ADDENDUM 01

DATE: July 24, 2014
TO: Continental 294 Fund LLC
FROM: Scott Tabary
Duplantis Design Group, PC
SUBJECT: Spring at Fremaux Town Center
Slidell, LA

MISCELLANEOUS CHANGES, ADDITIONS AND CORRECTIONS TO DRAWINGS:

DRAWN DGS
CHECKED DEB
ISSUED DATE 7/24/14
ISSUED FOR PERMITTING
PROJECT NO. 14-248
FILE 14-248 DETAILS
SHEET D-5

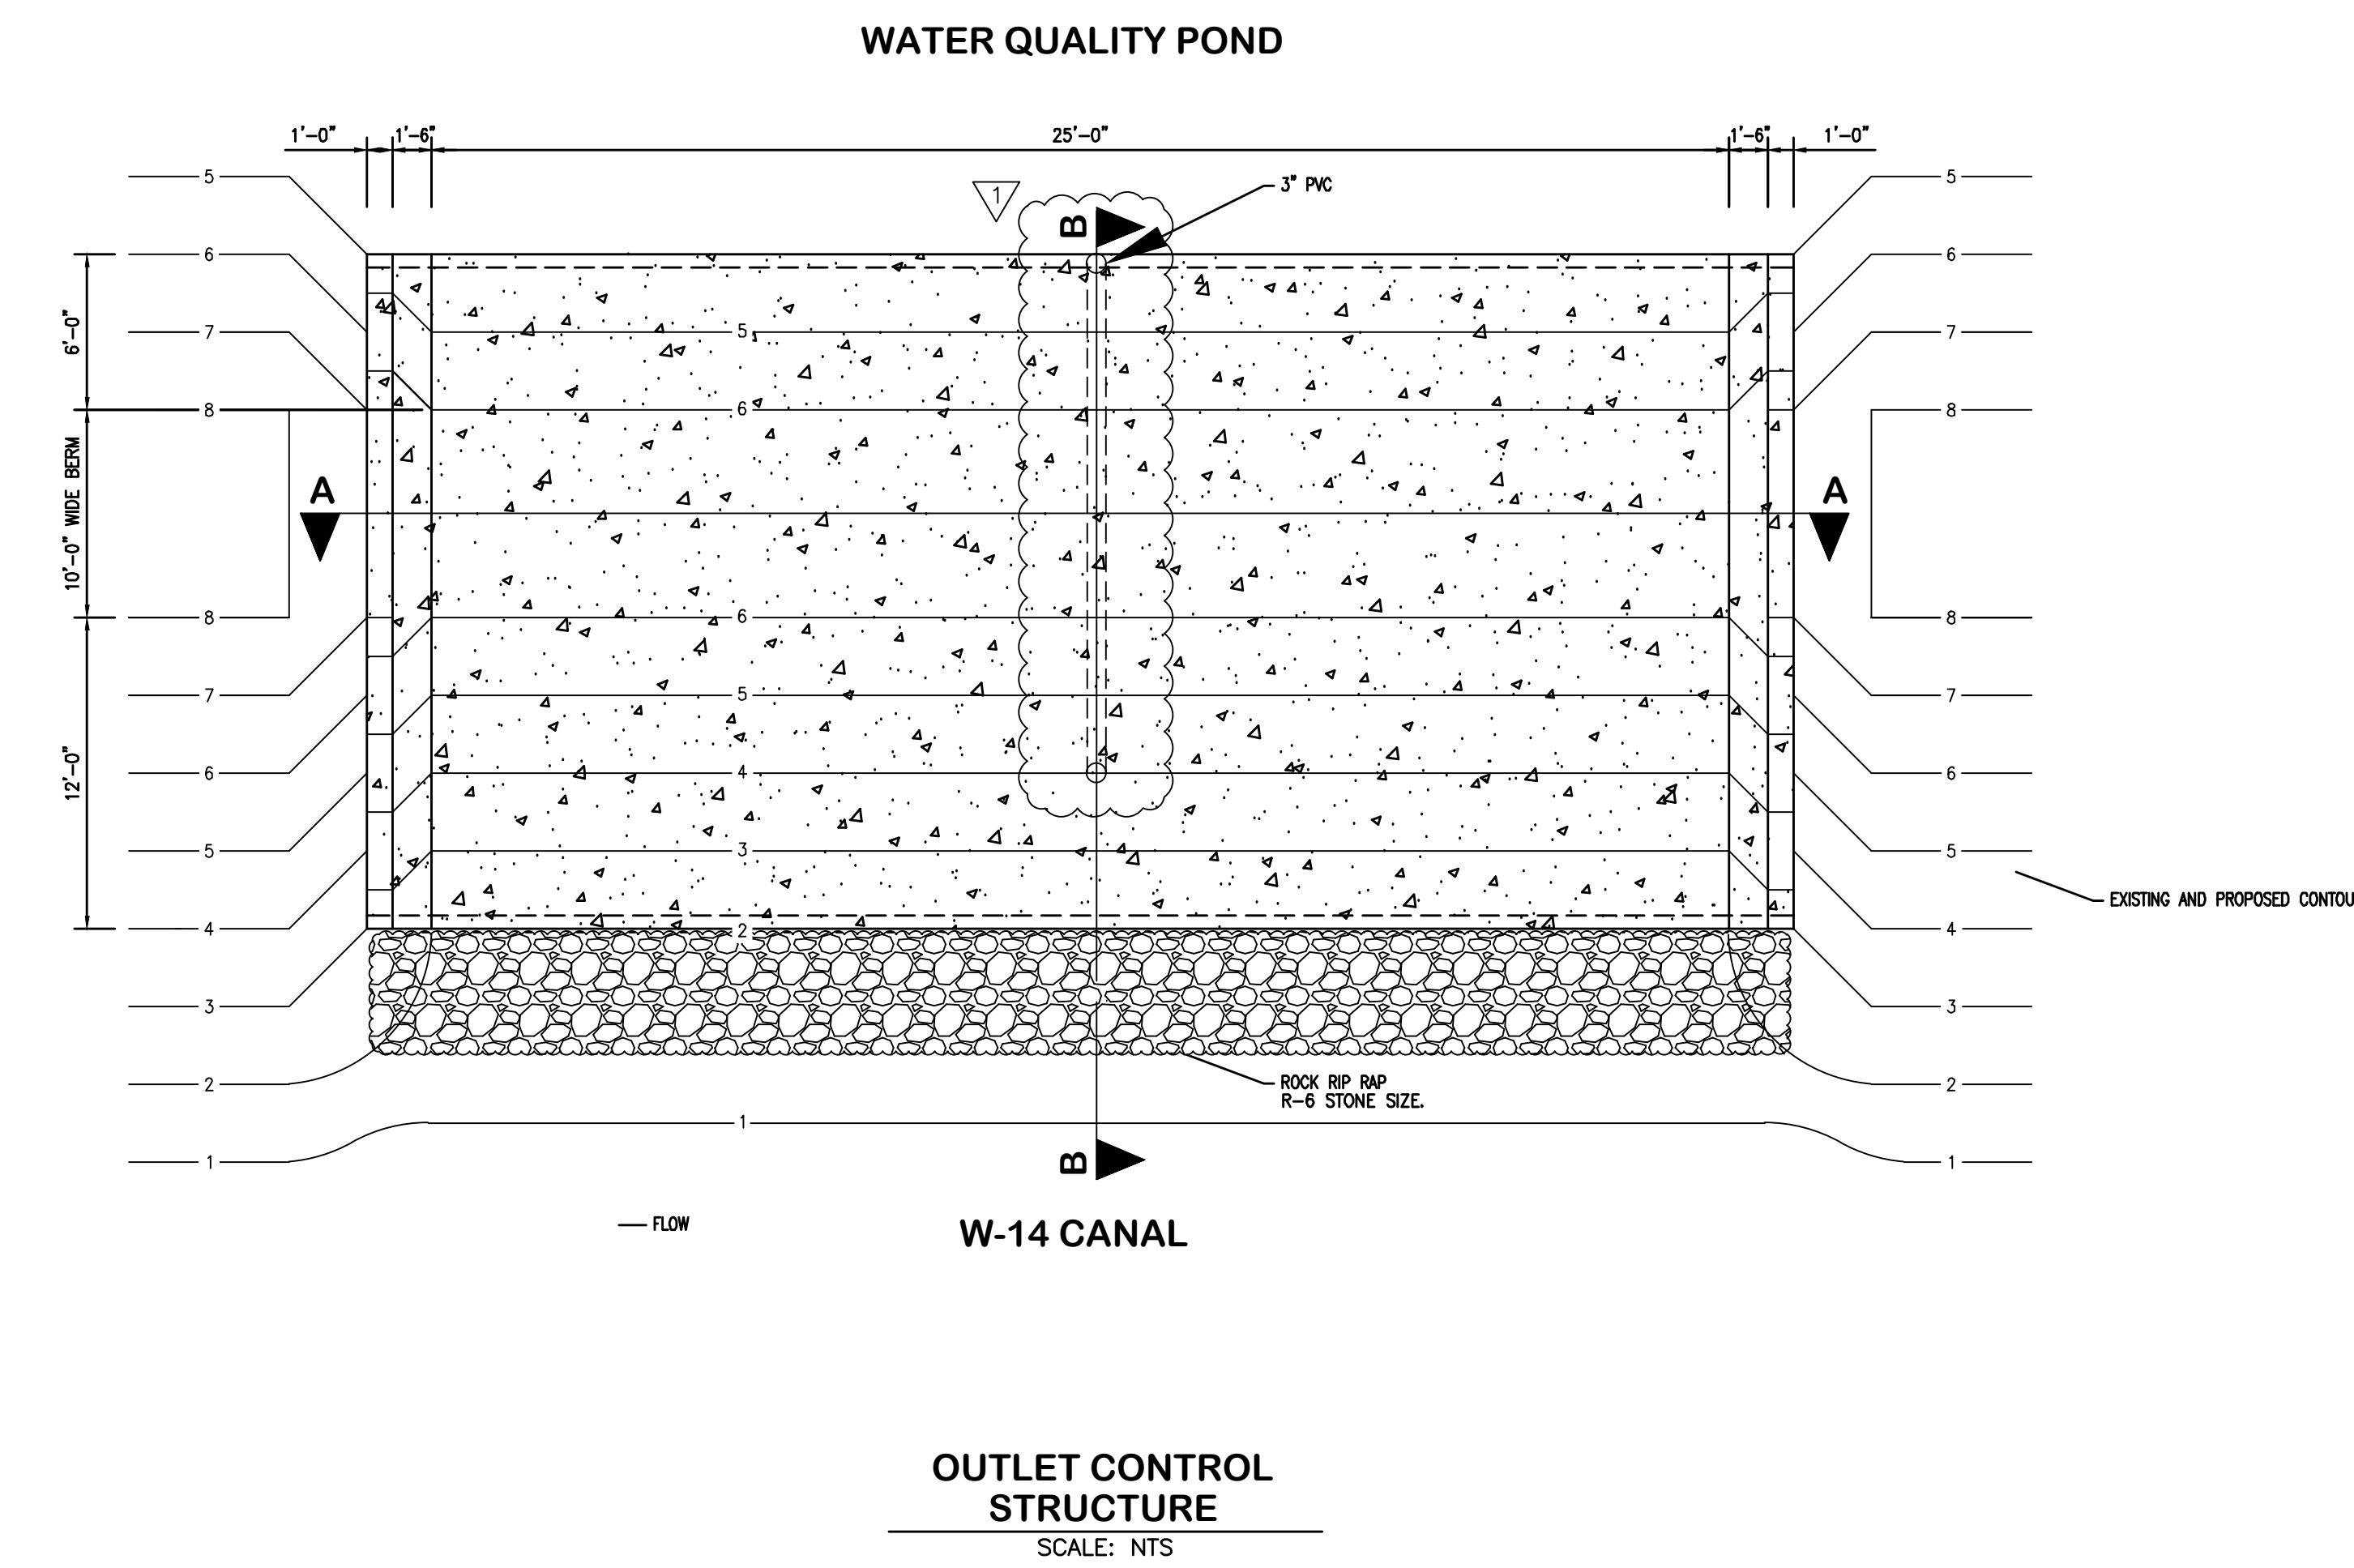
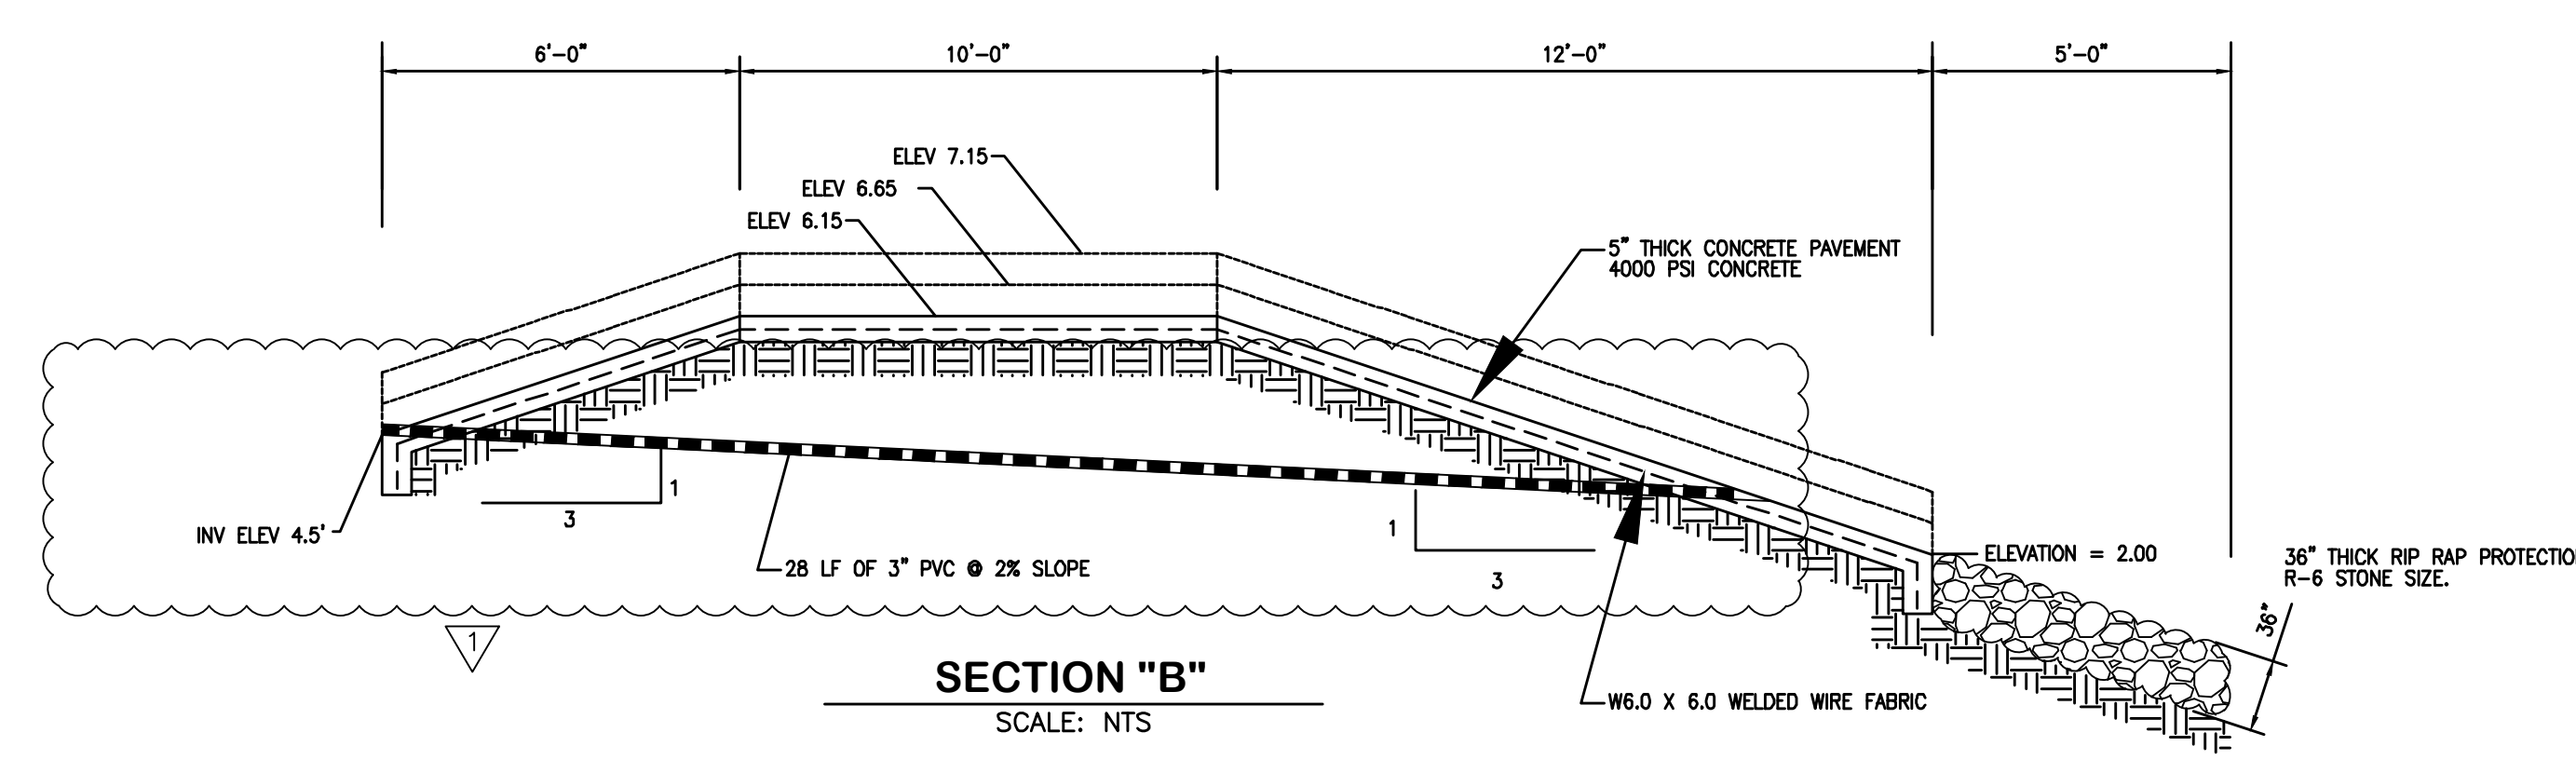
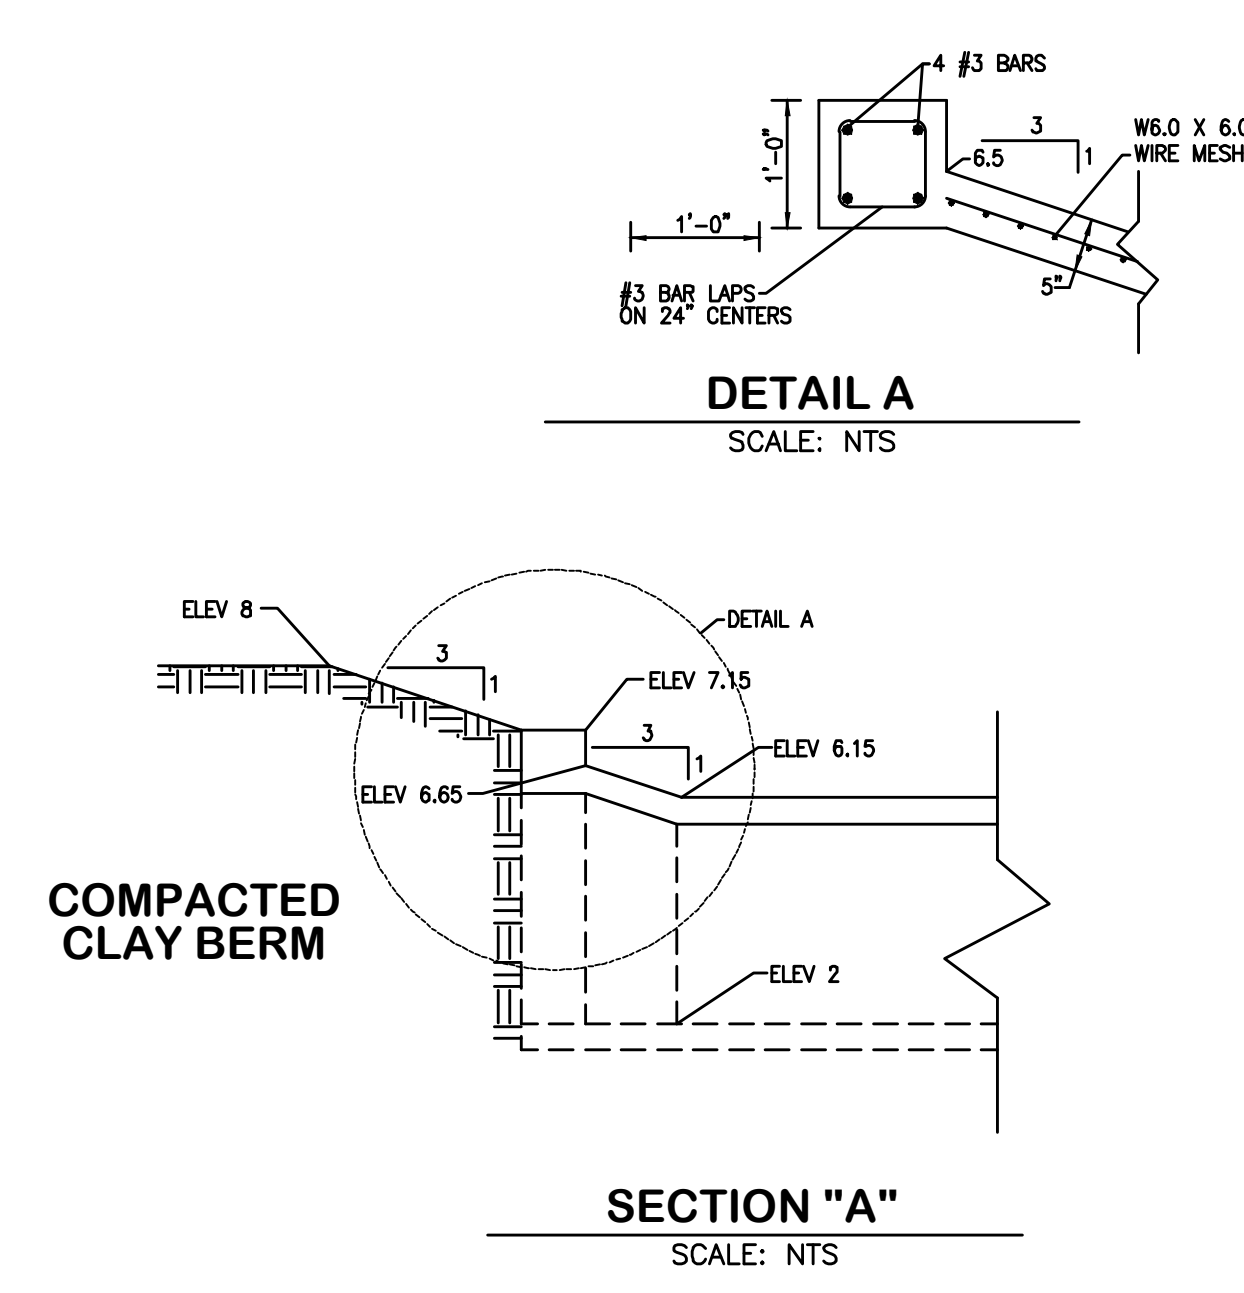
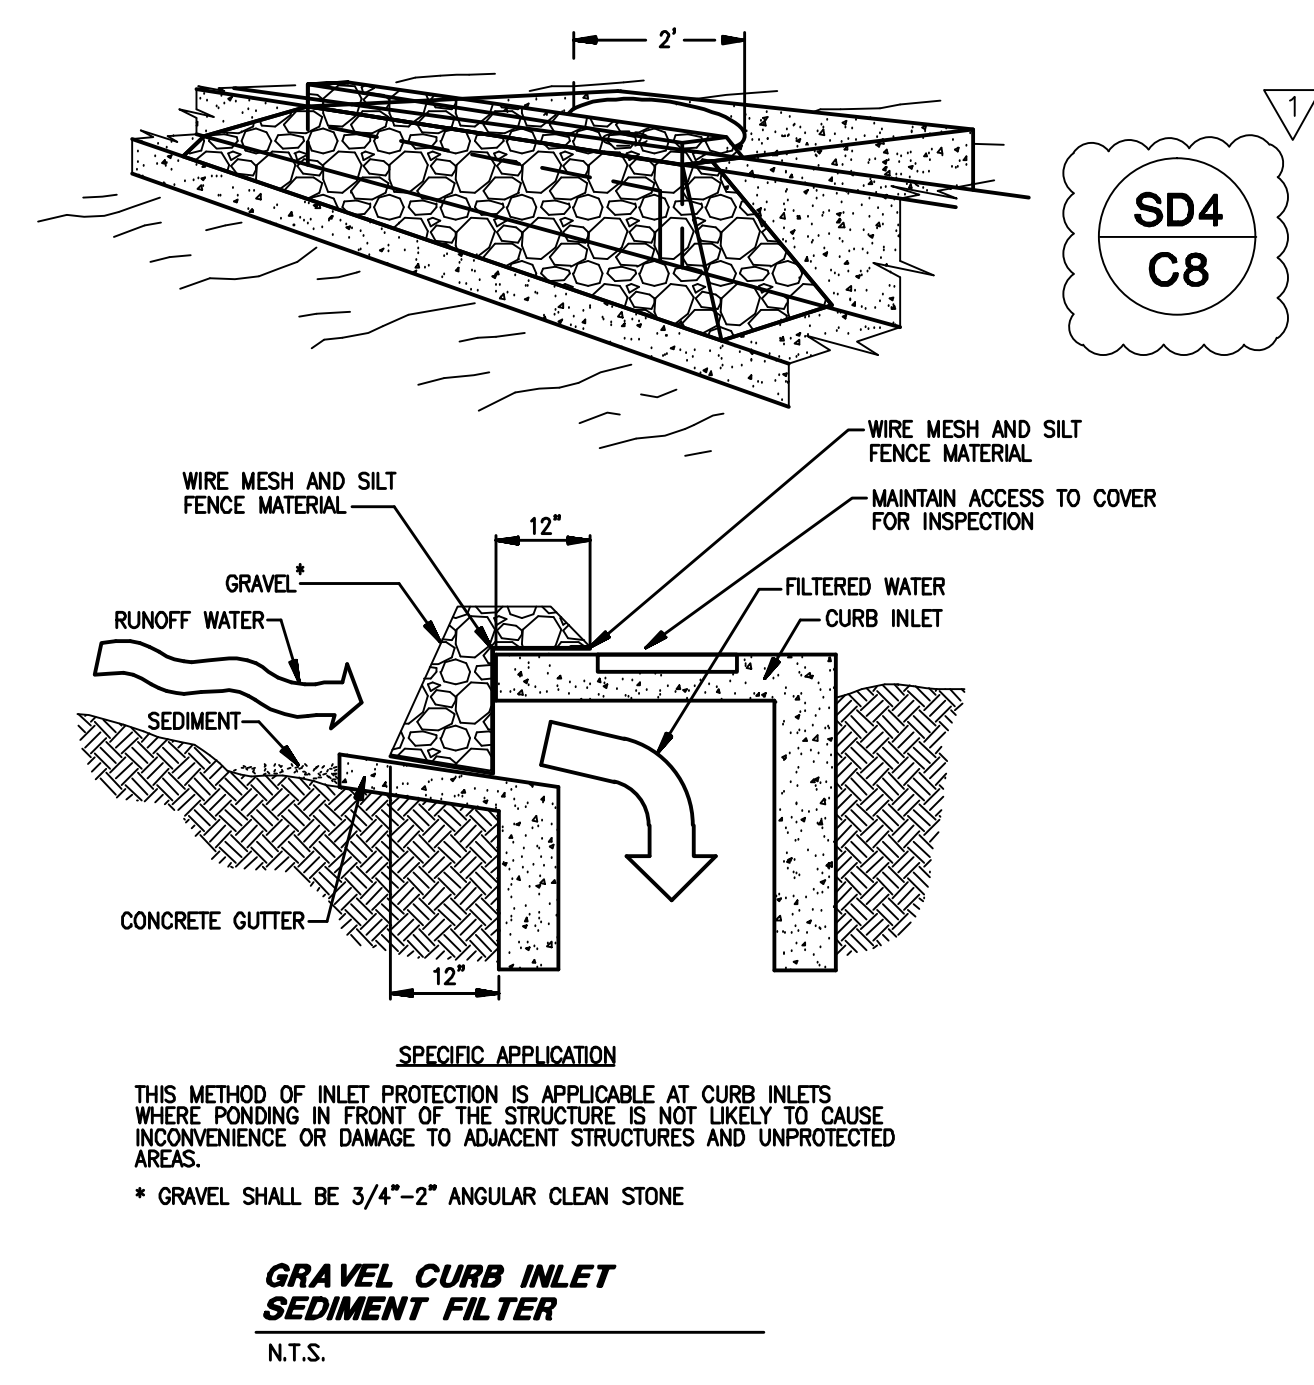
V. Sheet D-5

1. Updated Special Detail referring to Erosion Control Plan.
2. Updated Outfall Weir Detail with 3" bleeder pipe.
